Discussion of “*Monitoring Secondary Moments of Continuous Unbonded Post-Tensioned Concrete Beams*,” Kyungmin Kim and Thomas H.-K. Kang, published in *PTI JOURNAL*, December 2018, pp. 5-16

BY KENNETH B. BONDY

Closure to Discussion by Kenneth B. Bondy concerning “Monitoring Secondary Moments of Continuous Unbonded Post-Tensioned Concrete Beams,” Kyungmin Kim and Thomas H.-K. Kang, *PTI Journal*, December 2018, pp. 5-16

BY KYUNGMIN KIM AND THOMAS H.-K. KANG

Fig. D3—Support reaction data from all specimens. (Note: 1 kN = 0.225 kip.)

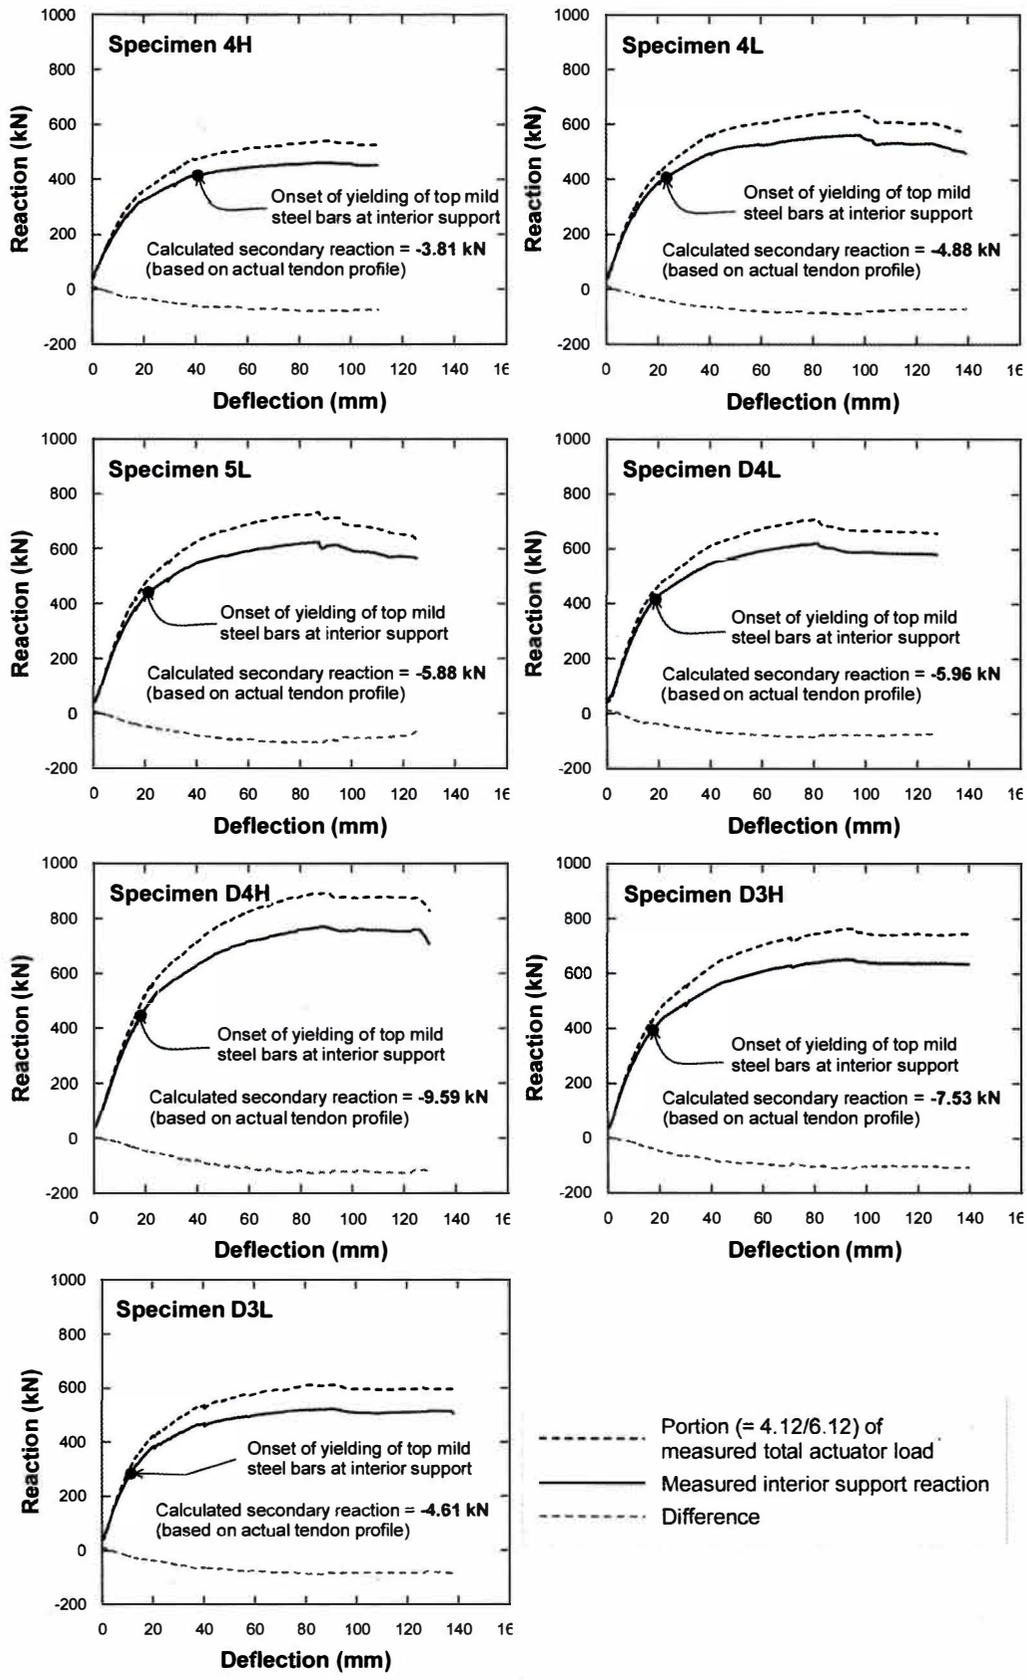
This discussor performed independent calculations for secondary moments in the test beam 4L, using commercially available software which has been calculating secondary moments in more than 700 structural design offices worldwide since 1983. These calculations indicate a secondary moment at the interior support of 17 ft-kip (22.9 kN-m) approximately 57% higher than that calculated by the authors in Table 3 (11 ft-kip [14.6 kN-m]) and still only one-sixth of their "measured" value for that beam (103 ft-kip [139.6 kN-m]). In these calculations,

a compound-parabola tendon profile was used with four parabolas in each span, two concave downward at the supports and two concave upward between them, with inflection points at one-tenth of the beam span from each support (the "Type 3" tendon profile in the commercial software). This was done because the authors seem to be critical of the commonly used single-parabola "ω-shaped profile with kink," as they describe it in the second paragraph under "OBSERVATION AND DISCUSSION". Using this tendon profile slightly reduced the calculated values of the secondary effects from those calculated with a single-parabola "kinked" profile. This means that both the authors' calculated and measured values of secondary moments, as presented in Table 3, are highly suspect.

Figure 10 of the original paper is re-plotted using the original data in Fig. D3, along with the data of the other specimens D3H, D3L, D4H, and D4L. The load cell installed at the interior support was checked using a universal testing machine before and after the beam testing, so the interior support reaction histories are correct for all seven specimens. The black dashed line is obtained from the total applied load multiplied by (4.12/6.12). This ratio is from the elastic analysis as shown in Fig. D4, and is expected to be the same until plastic moment is reached. The difference (hold-down force) is also plotted. Under internal bending moment

The authors would like to stress that the secondary reaction was very small with self-weight only before the external loading was applied, which is consistent with the calculated secondary reaction (−9.59 to −3.81 kN [−2.16 to −0.86 kip]). However, secondary reaction appeared to increase significantly as the loading increased.

Fig. D5—Support moment (adapted from Mattock et al. 1971a).

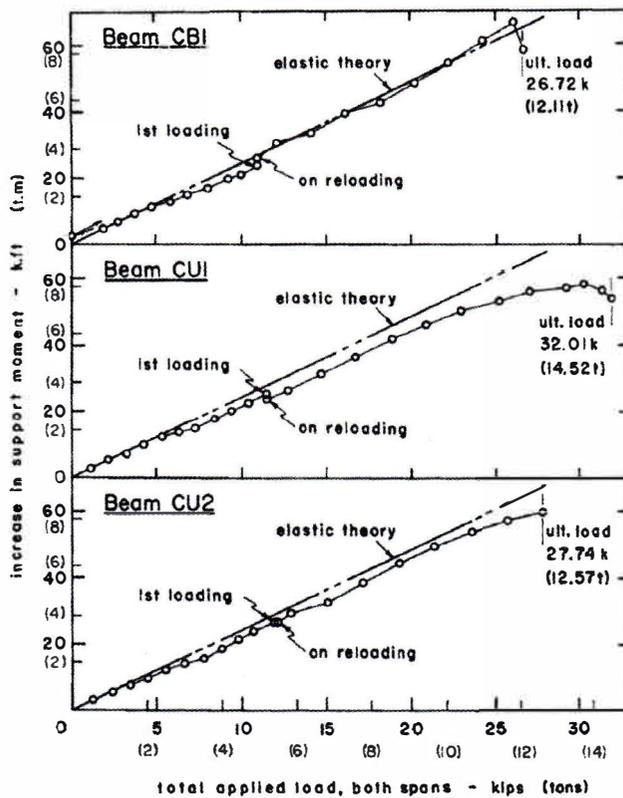
The authors point out that few researchers have measured secondary effects in their testing. However, one highly credible researcher, Alan Mattock, did in fact measure them in his classic work on indeterminate post-tensioned beams in 1969.² In this work, the researchers measured the center reaction in three two-span beams caused by dead load and prestress forces (including significant secondary effects) and found that the measured value ranged between 1.006 and 1.02% of the calculated value (using the normal method for calculating secondary moments—the authors' Eq. (10)). That is strikingly good agreement and differs wildly from the results presented by the authors of this paper. So the authors' conclusion that their measured secondary moments were 10 times larger than the calculated values is seriously at odds with not just the observable behavior of existing post-tensioned beams, but at least one highly respected and influential research publication.

In regard to Mattock's research (Mattock et al. 1971a, b), the authors do not have the full University of Washington report by Yamazaki, Kattula, and Mattock. As such, it is unclear to the authors as to how center support moment was obtained according to Mattock et al.'s ACI papers (1971a, b) and depicted in Fig. 7 therein (refer to Fig. D5 herein). The authors believe that this was not measured center support "reaction," but center support moment derived based on other information, because no center reaction histories were provided.
